ENGINEER'S DAILY REPORT

04-SF-80-13.2/13.9
Contract No. 04-0120F4
{SAS Superstructure}

REQUEST FOR INFORMATION (RFI)

Subject: Existing Ground Cables at Pier E2
References:
Sub/Sup: ABF Sub RFI #:
Response Required by: 08-August-2008 Response affects critical path activity?

RFI-1462-SK-E-22

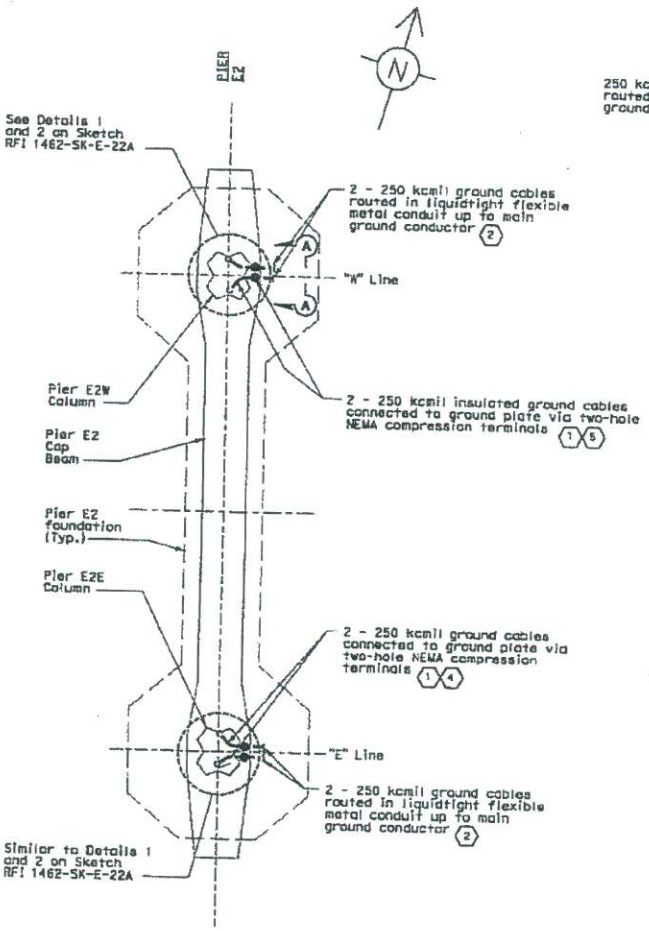
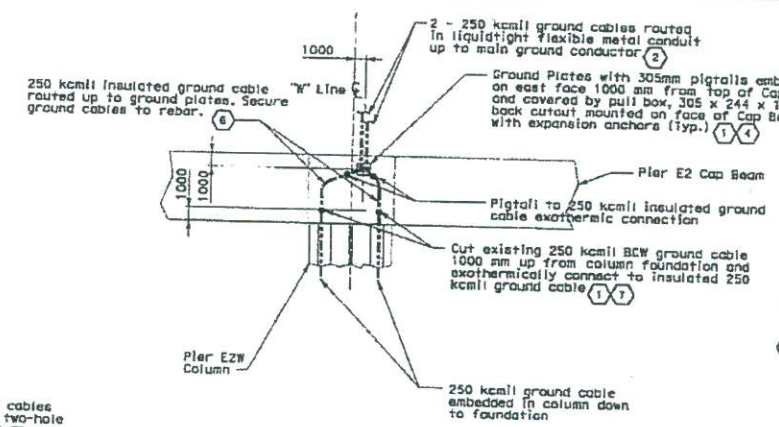
1) Routing of ground cable through cap beam reinforcement and other embedded material

2) Unknown length of existing ground cable coils and whether or not they must be extended by "cadwelding" additional cable

3) Exit points for ground cables through cap beam

4) Protection (i.e. conduit) against physical damage for ground cables through cap beam

The attached sketches RFI-1462-SK-E-22 and RFI-1462-SK-E-22A covers discussion topics 1 - 4:

1. Please see the attached sketches for routing of the ground cables through the cap beam reinforcement.

2. The existing ground cables should be extended to reach the ground plate locations shown on the sketches. Additional cables should be insulated cables and exothermically welded to the existing cables.

3. The termination points (exit points) of the ground cables shall be located at the ground plates as shown on the sketches.

4. Protection of the ground cables in the cap beam should be provided by the following methods:
A. Use insulated cables for additional ground cables and exothermically weld the connections.
B. Seal exposed bare copper cables and exothermic connections with heavy duty splicing tape and vinyl electrical tape.

1. Install two grounding plates, Thermoweld Type CA-27 Cat. #38-4533-68 (sized for 250 kcmil with 305mm pigtail). Exothermically connect 250 kcmil insulated ground cable (2 per column) to the embedded ground plate pigtail located on the east face and route to the existing 250 kcmil BCW cut 1000 mm above the cap/column construction joint. Route the cables through the cap beam. See contract 04-0120E4 for limited scope of work.

2. Route 2-250 kcmil ground cables from the embedded ground plates in the cap beam above the E2E & E2W columns in liquidtight flexible metal conduit up to 500 kcmil ground cable run with Eastbound and Westbound 15 kV cable tray.

4. Pull box shall be 305 x 244 x 154 stainless steel enclosure with cutout in back to protect grounding plates and connections. Box sall be mounted to face of Cap Beam with expansion bolts. Place Neoprene O-Ring gasket around opening between box and concrete face to inhibit moisture encrosion.

5. Ground cable connections to grounding plate shall be with Burndy heavy duty two-hole NEMA pattern compression terminals.
6. Route 250 kcmil insulated ground wire within Cap Beam. Use green trace tape on ends of cable if green insulation not available. Secure to inside of existing vertical perimeter rebar cage and connect to embedded grounding plate on east face of Cap Beam. Contractor to verify insulated ground wire cable length.

7. Seal exposed bare copper wire (BCW) and exothermic connections with heavy duty splicing tape and vinyl electrical tape.
